**GENOA CHARTER TOWNSHIP
PLANNING COMMISSION PUBLIC HEARING
APRIL 10, 2017
MONDAY
6:30 P.M.
AGENDA**

Attention:	Kelly Van Marter, AICP Assistant Township Manager and Planning Director
Subject:	Chem Trend Storage Building – Sketch Plan Review #1
Location:	3205 E. Grand River Avenue – north side of Grand River, west of Latson Road
Zoning:	IND Industrial District

Attention:	Kelly Van Marter, AICP Planning Director and Assistant Township Manager
Subject:	Consumers Energy – Site Plan Review #1
Location:	1000 Grand Oaks Drive – west side of Grand Oaks, south of Grand River Avenue
Zoning:	IND Industrial District

EXTERIOR ELEVATIONS SCALE: 1/4" = 1'-0"

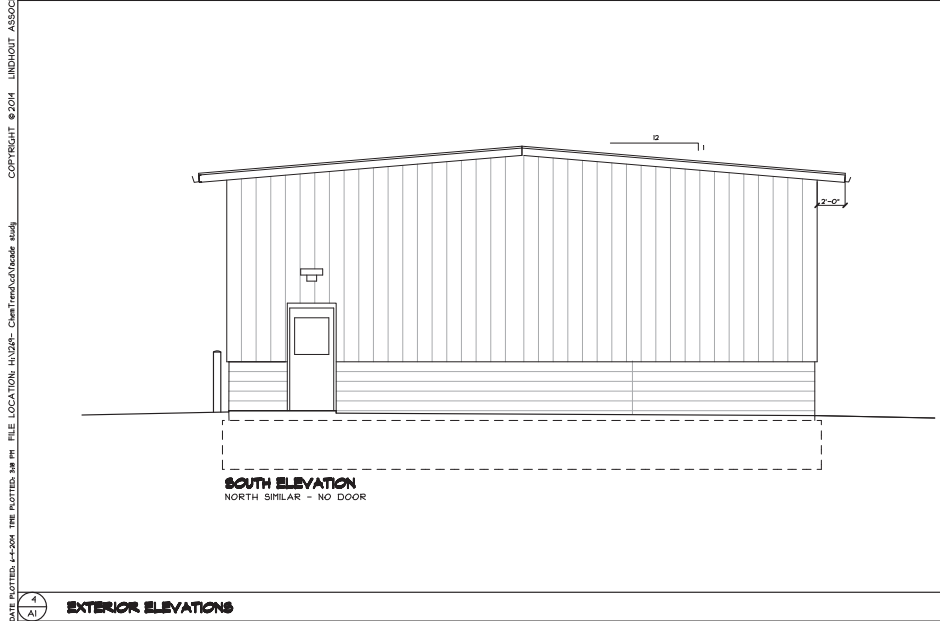
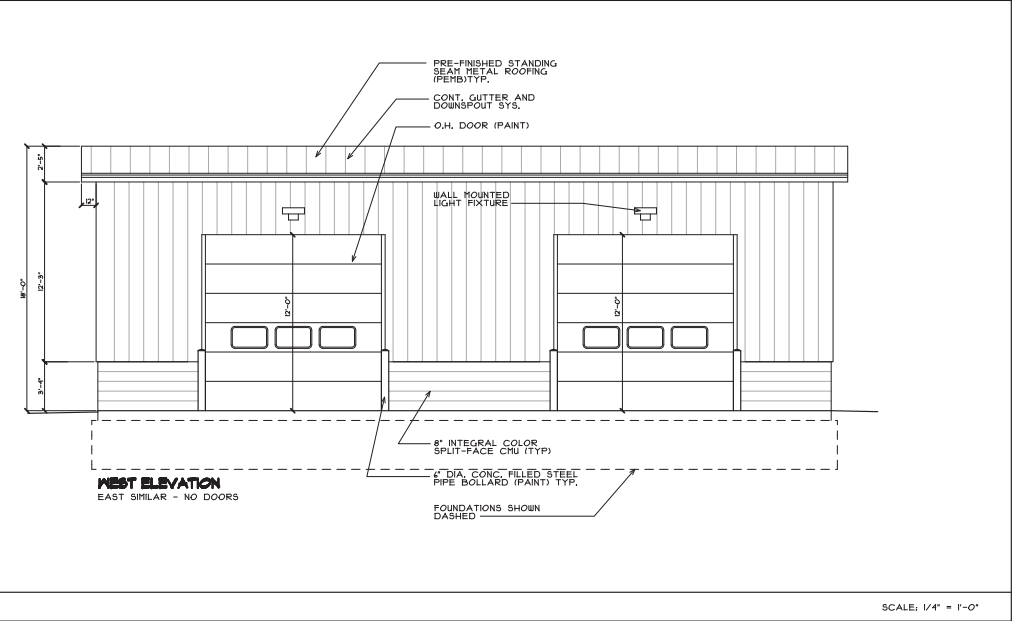
- 2. Building Materials and Design.** The proposed elevations, including colors and materials, are subject to review and approval by the Planning Commission. Building elevation drawings are found on Sheet A1.00. We request the applicant be prepared to present a material and color sample board at the upcoming meeting.

In this instance, the Commission could allow a modification given that the main building is clad in metal siding and the proposed building will not be visible from the roadway.

- 3. Exterior Lighting.** The building elevation drawings show 3 wall mounted light fixtures. Detail sheets included with the submittal note the use of downward directed, cut-off LED fixtures, per Ordinance standards.

WEST ELEVATION

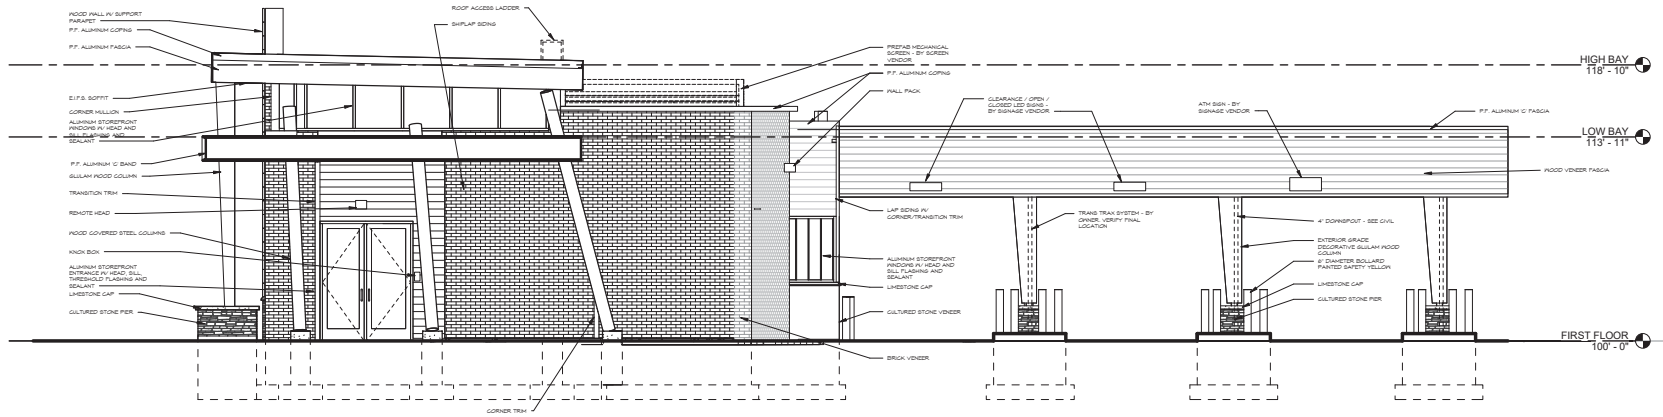
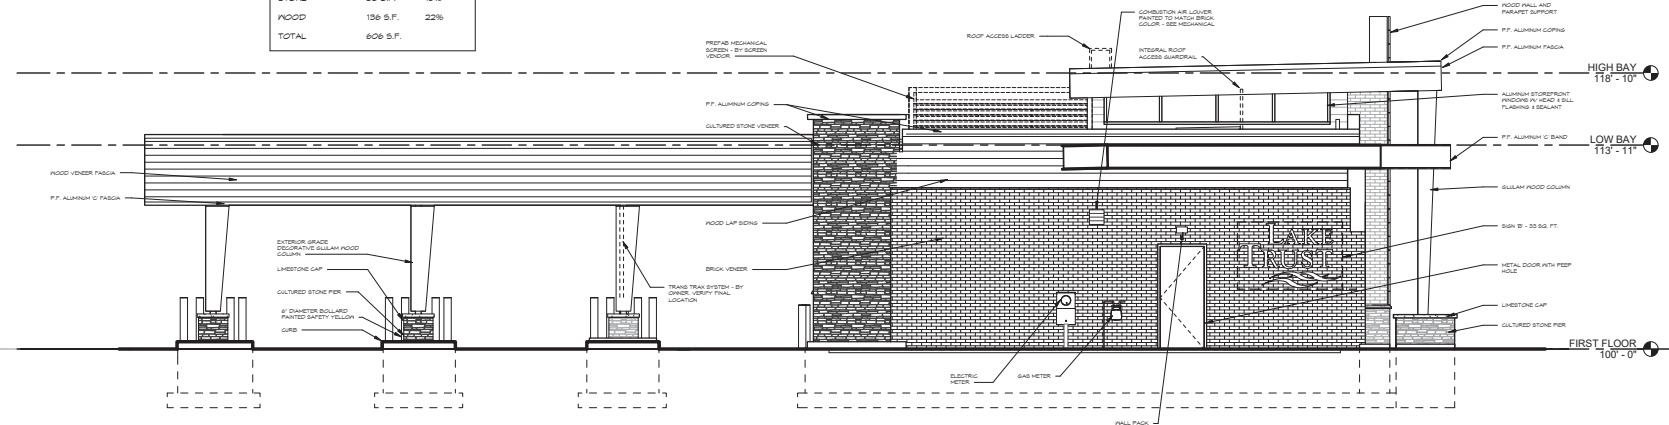
2. Building Materials and Design. The proposed elevations, including colors and materials, are subject to review and approval by the Planning Commission. Building elevation drawings are found on Sheets A-301 and A-302. The submittal also includes color renderings, and the applicant has indicated that they intend to present material samples at the upcoming meeting.
